Access Compliance Report

Public Rights-of-Way

(Curb Ramps)

Intersection ID: 15800	Main Street: PROVIDENCE_RD	Cross Street: QUEENS_RD	Location: NE
ADA ID: AC728B675321	Ramp Type: Perp	Initial Pass/Fail: Fail	Overall Compliance: No
Codes/Mitigation Info/Possible Solution		Field Measurements/Component Compliance	
Severity Score: 8.75

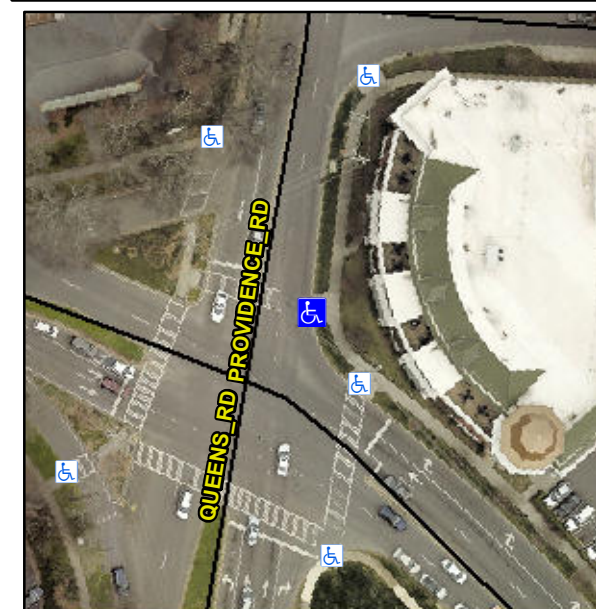
PROW/ADA:

Not Found, R304.5.1

Compliance	Description	Data	Compliance	Description	Data
N/A	Ramp Length (in)	95.5	Yes	Ramp Slope (%)	5.2
No	Ramp Width (in)	46.0	Yes	Ramp XSlope (%)	1.1
N/A	Flare Type LT	N/A	N/A	Flare Type RT	N/A
N/A	Flare Slope LT (%)	N/A	N/A	Flare Slope RT (%)	N/A
N/A	Flare Traversable LT?	N/A	N/A	Flare Traversable RT?	N/A
N/A	Landing Length (in)	N/A	N/A	DWS Provided?	N/A
N/A	Landing Width (in)	N/A	N/A	DWS Contrast?	N/A
N/A	Landing Slope (%)	N/A	N/A	DWS Length (in)	N/A
N/A	Landing X Slope (%)	N/A	N/A	DWS Full Width?	N/A
N/A	Landing Curb? (Y/N)	N/A	N/A	DWS Offset (in)	N/A
N/A	Shared Landing?	N/A			
N/A	Gutter Ponding?	N/A	N/A	Gutter Slope (%)	N/A
N/A	Gutter Lip Ht (in)	N/A	N/A	Gutter X Slope (%)	N/A
N/A	Painted X Walk1?	Yes	N/A	Painted X Walk2?	N/A
	X Walk 1 Direction	To NW		X Walk 2 Direction	N/A
N/A	X Walk 1 Width (in)	104.0	N/A	X Walk 2 Width (in)	N/A
	X Walk 1 Slope (%)	0.8		X Walk 2 Slope (%)	N/A
	X Walk 1 X Slope (%)	0.5		X Walk 2 X Slope (%)	N/A

Remove & Replace Entire Ramp.
